Reference: NHTSA Identification Number 09E-001

Enclosure: Revised Recall H46

Revised May 2009

Safety Recall H46 - Mopar Steering Linkage

Figure 16 – Align Left Tie Rod Socket Parallel to Left Steering Knuckle

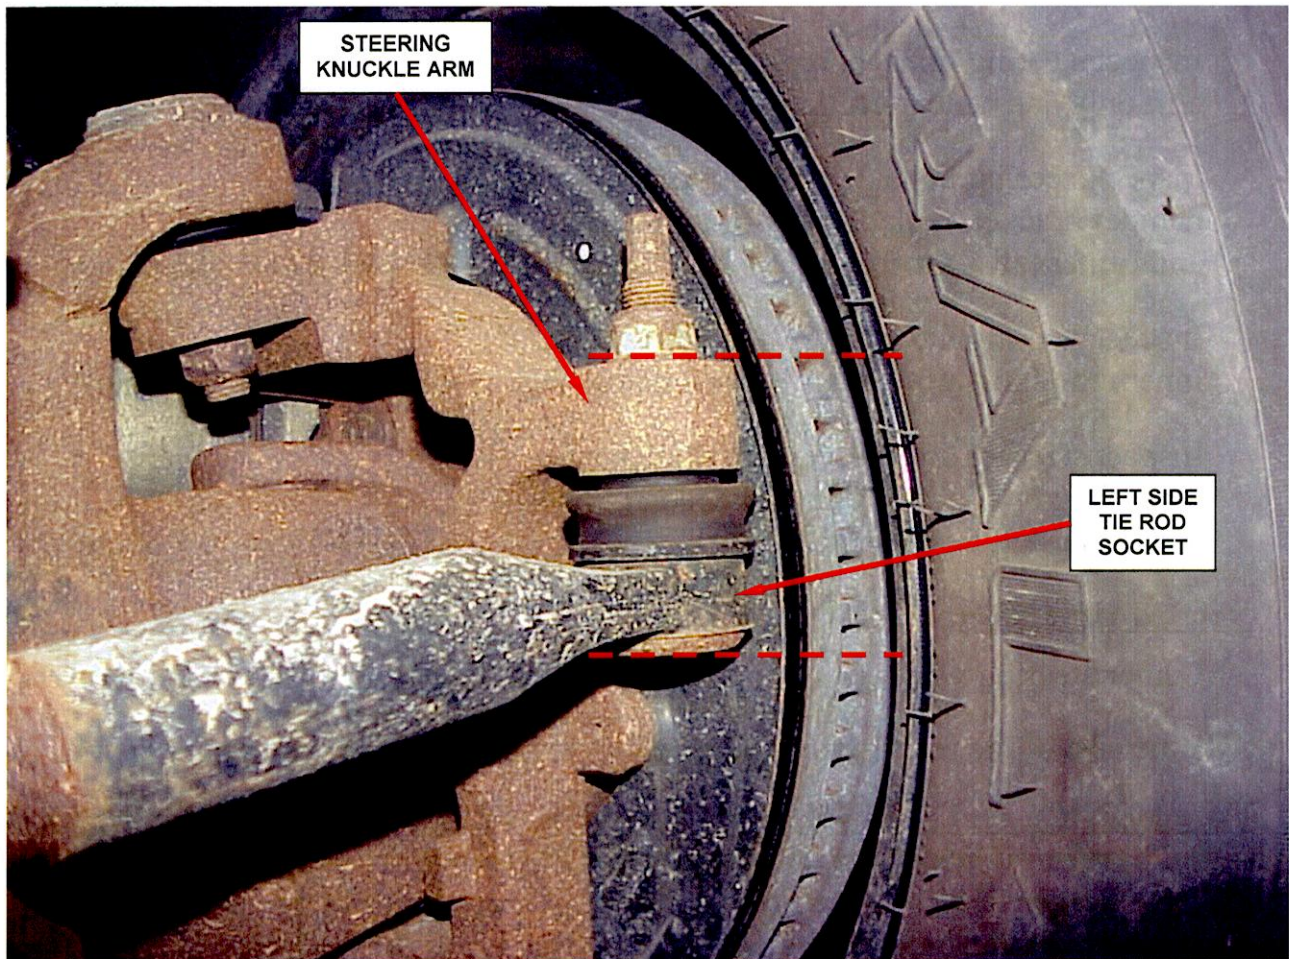
Enclosed are updated copies of the dealer communications which revises the service procedure to include an inspection of the left outer tie rod alignment.

9. Verify the lower surface of the left outer tie rod socket is parallel to the upper surface of the left knuckle attaching arm using the following procedure:
 - a. Loosen the tie rod tube adjuster sleeve clamps.
 - b. Rotate the left tie rod until the bottom of the tie rod socket is parallel to the top of the left steering knuckle arm (Figure 16).
 - c. Tighten the tie rod adjuster sleeve clamp nuts to 45 ft. lbs. (61 N·m).

CAUTION: Failure to align the left tie rod end parallel to the steering knuckle could cause tie rod end damage.
